GXV3240/GXV3275 Firmware Release Note

FIRMWARE VERSION 1.0.3.180

GXV3240, GXV3275

DNS SRV FAILOVER MODE

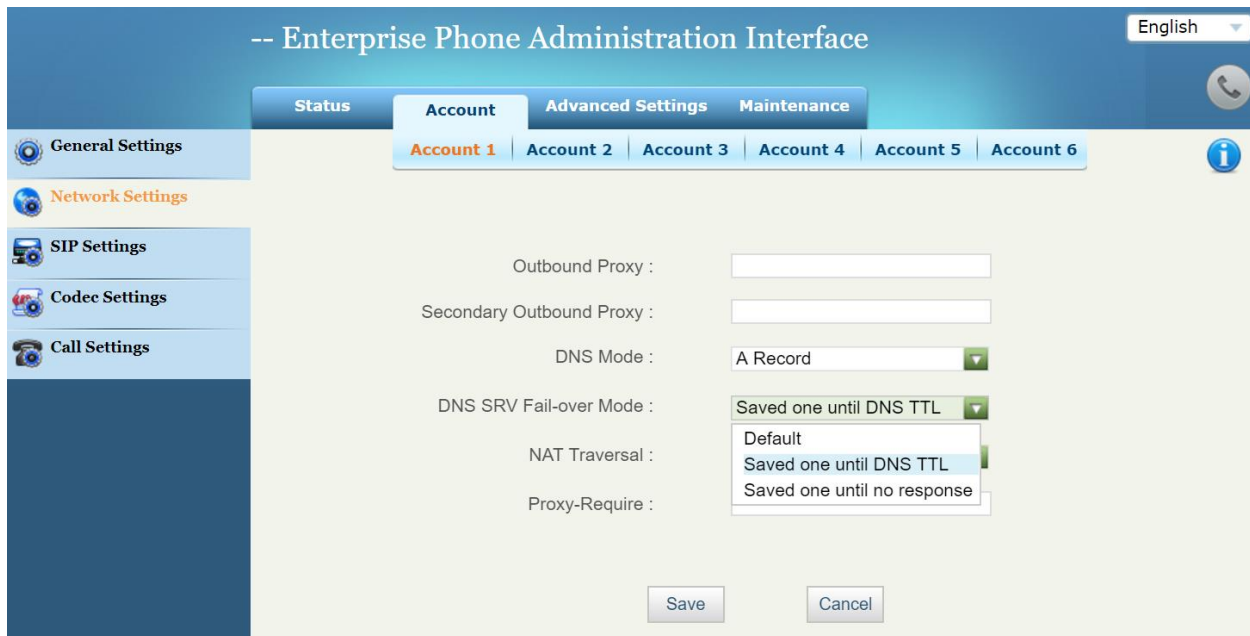
- Improved Wi-Fi module for security vulnerability concerns.
- Added web UI -> Account -> Network Settings -> DNS SRV Fail-over Mode. [DNS SRV FAILOVER MODE]

- If "default" is selected, first IP from query result will be applied;
- If "Saved one until DNS TTL" is selected, first IP will be applied before DNS timeout;
- If "Saved one until no response" is selected, first IP will be applied even after DNS timeout until it cannot respond.

CALL FORWARD WHEN ON DND

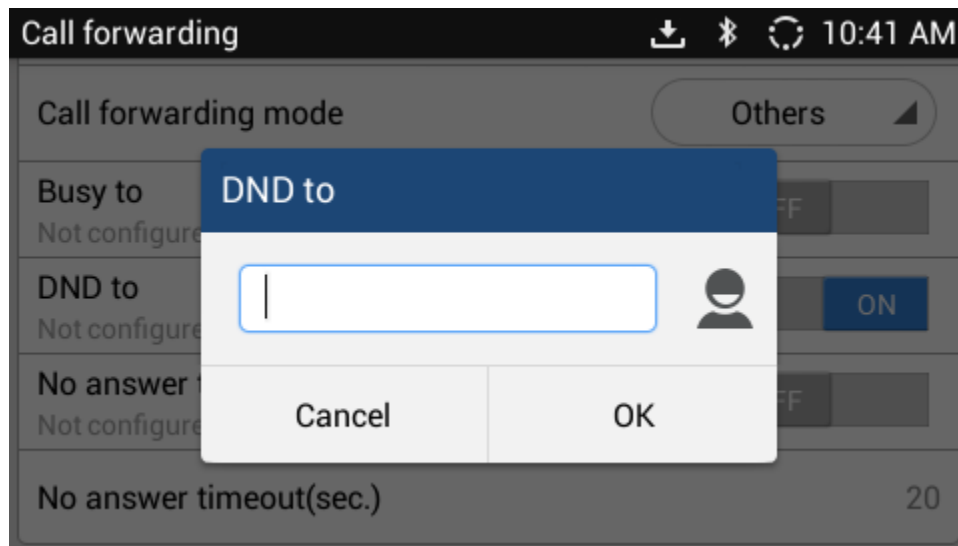
- Added LCD -> Settings -> Personalized account -> Account -> Call forwarding -> Call forwarding mode: Others -> "DND to". [CALL FORWARD WHEN ON DND]
- Supported syslog over SSL/TLS. By uploading CA certificate, the syslog can be sent via TLS rather than default UDP. To upload a CA certificate, insert a SD card with the CA, then go to LCD -> Settings -> Security settings -> Install from SD card.

This option is under LCD -> Settings -> Personalized account -> Account -> Call forwarding -> Call forwarding mode: Others -> "DND to". Enable the feature first and tap on the item to edit number. This allows users to add forward number if the account is set to DND.
